Town of Parker Community Development Department
Development Review Division
Attention: **Stacey Nerger**

Application Type: **Site Plan**
Status: **First Referral**
Application Name: **Lincoln Professional Park F1 - Preliminary Site Plan**
Case/AP#: **SP21-107**
Referral Received: September 22, 2021
Comments Due: October 20, 2021

Review date: **October 14, 2021**
Plan reviewer: **Randall L. Capra, rcapra@parkeronline.org**
Phone: 303.805.3163

TOWN OF PARKER FIRE/LIFE SAFETY:	R REVIEWED FOR CODE COMPLIANCE; REVISIONS REQUIRED
---	---

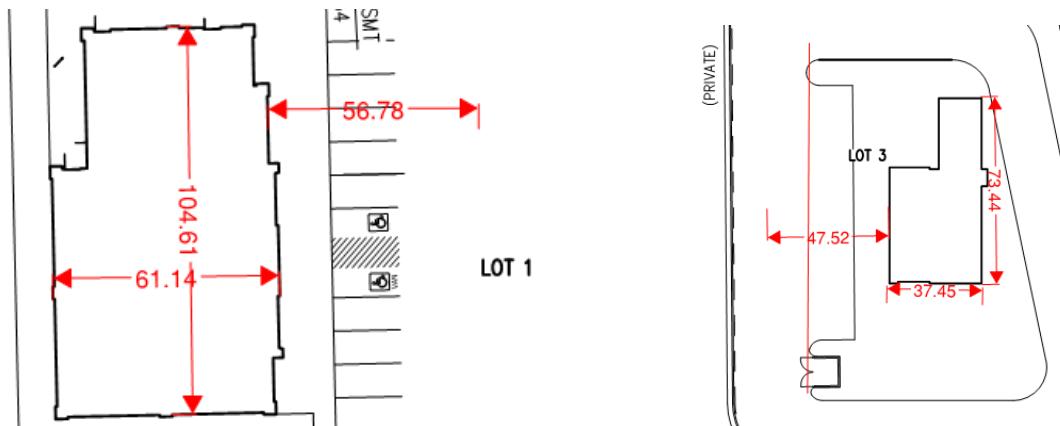
8. **Sheet 3 Overall Utility:** The overall utility drawings are incomplete; the plan set does not address fire hydrant locations for the spine roads proposed. The applicant shall address this issue and fire hydrants will be required in the following locations while noting that additional hydrants will be required on the internal lots depending upon access and use (the gas station will be required to be sprinklered as will Lot 3... as currently shown):

- The entry off of Dransfeldt Road on to Road A
 - The entry off of Lincoln Ave and the current Private Drive
 - Road A (required extension) into Lot 1 Filing No.2 Peaslee Subdivision at Road A and Lot 1

- At the corner of Road B and the Private Drive
 - At the corner of Road A and Road B
 - At the entry of the gas station off of Road A

See below for locations required:

9. The applicant shall be aware that additional fire hydrants (on each individual lot) will be required based upon access, occupancy type, etc. (and certainly based upon what was shown on the submittal documents). This requirement (complying with NFPA 24, section 7.2.3) will be evaluated for each individual lot as applications are submitted though it would be advisable for the applicant to plan accordingly so that cuts into new infrastructure can be avoided.
